Access Compliance Report

Public Rights-of-Way

(Curb Ramps)

Intersection ID: 10020394	Main Street: BALLANTYNE CROSSING AV	Cross Street: N/A	Location: NE
ADA ID: 60E9E6FBEBBE	Ramp Type: PerpDiag	Initial Pass/Fail: Fail	Overall Compliance: No
Severity Score: 26.25			
Codes/Mitigation Info/Possible Solution		Field Measurements/Component Compliance

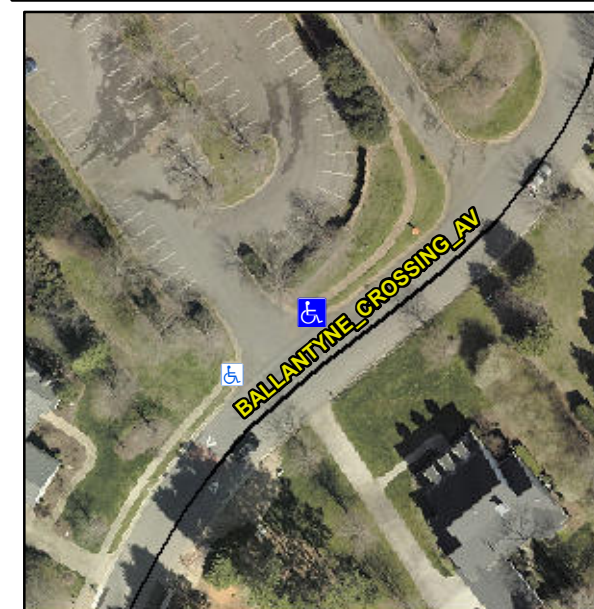
Not Found, R304.2.2, R304.5.3

Compliance	Description	Data	Compliance	Description	Data
N/A	Ramp Length (in)	48.0	No	Ramp Slope (%)	13.0
Yes	Ramp Width (in)	48.0	No	Ramp XSlope (%)	4.9
N/A	Flare Type LT	N/A	N/A	Flare Type RT	N/A
N/A	Flare Slope LT (%)	N/A	N/A	Flare Slope RT (%)	N/A
N/A	Flare Traversable LT?	N/A	N/A	Flare Traversable RT?	N/A
N/A	Landing Length (in)	N/A	N/A	DWS Provided?	N/A
N/A	Landing Width (in)	N/A	N/A	DWS Contrast?	N/A
N/A	Landing Slope (%)	N/A	N/A	DWS Length (in)	N/A
N/A	Landing X Slope (%)	N/A	N/A	DWS Full Width?	N/A
N/A	Landing Curb? (Y/N)	N/A	N/A	DWS Offset (in)	N/A
N/A	Shared Landing?	N/A			
N/A	Gutter Ponding?	N/A	N/A	Gutter Slope (%)	N/A
N/A	Gutter Lip Ht (in)	N/A	N/A	Gutter X Slope (%)	N/A
N/A	Painted X Walk1?	No	N/A	Painted X Walk2?	No
	X Walk 1 Direction	To SW		X Walk 2 Direction	To SE
N/A	X Walk 1 Width (in)	N/A	N/A	X Walk 2 Width (in)	N/A
	X Walk 1 Slope (%)	4.4		X Walk 2 Slope (%)	7.6
	X Walk 1 X Slope (%)	0.0		X Walk 2 X Slope (%)	8.2

Remove & Replace Curb Ramp With Two New Directional Ramps or Equivalent.
